DRAWING NO. D206-667-147	TITLE CROSSTUBE ASS'Y (206L MID FWD)	REV. A	DART AEROSPACE LTD ENGINEERING ORDER		D.E.O. NO. D206-667-147-A-1	SHEET NO. SHEET 1 OF 1	SCALE NTS
DRAWN <i>qp</i>	CHECKED <i>ASS</i>	MFG. APPR. <i>EB</i>	APPROVED <i>MD</i>		DE APPR. <i>MD</i>		
DATE 11.07.15	DATE 11.07.20	DATE 11.07.21	DATE 11/07/21		DATE 11.07.21

REPLACE MAGNOBOND WITH PROSEAL.

DRAWING NO. D206-667-147		TITLE CROSSTUBE ASS'Y (206L MID FWD)		REV. A DART AEROSPACE LTD ENGINEERING ORDER		D.E.O. NO. D206-667-147-A-2		SHEET NO. SHEET 1 OF 1		SCALE NTS	
DRAWN AJS		CHECKED		MFG. APPR.		APPROVED		DE APPR.			
DATE 12.08.02		DATE 12.08.02		DATE 12.08.02		DATE 12.08.02		DATE 12.08.02

ADD ELECTRICAL GROUNDING STRAP

DETAIL P
BONDING STRAP INSTALLATION 2 PL

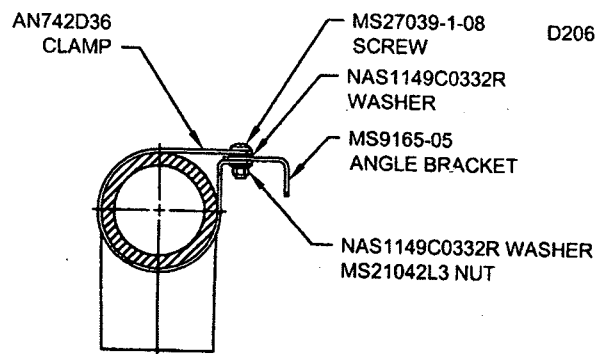
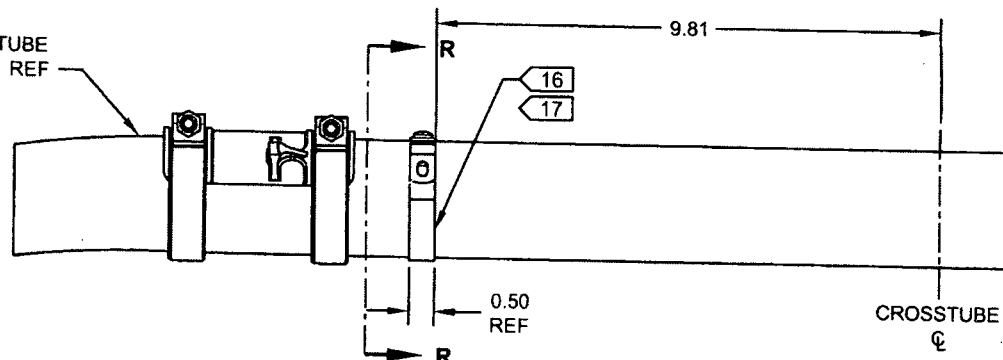
PARTS LIST:

ITEM	QTY -147	PART NUMBER	DESCRIPTION
1	X	D206-667-147	CROSSTUBE ASSEMBLY (206L MID FWD)
10	2	AN742D36	CLAMP
11	2	MS9165-05	ANGLE BRACKET
12	2	MS21042L3	NUT (OR MS21042-3)
13	2	MS27039-1-08	SCREW
14	4	NAS1149C0332R	WASHER (OR AN960C10L)

- 16) MASK AREA UNDER CLAMP PRIOR TO PAINTING
- 17) SEAL EDGES WHERE AN742D36 CLAMP MEETS WITH THE CROSSTUBE USING SIKAFLEX-241/-291 OR MIL-S-8802 CLASS B2 OR PROSEAL 890 SEALANT
- 18) PERFORM RESISTANCE CHECK TO ENSURE MAX RESISTANCE IS 10 MILLIOHMS
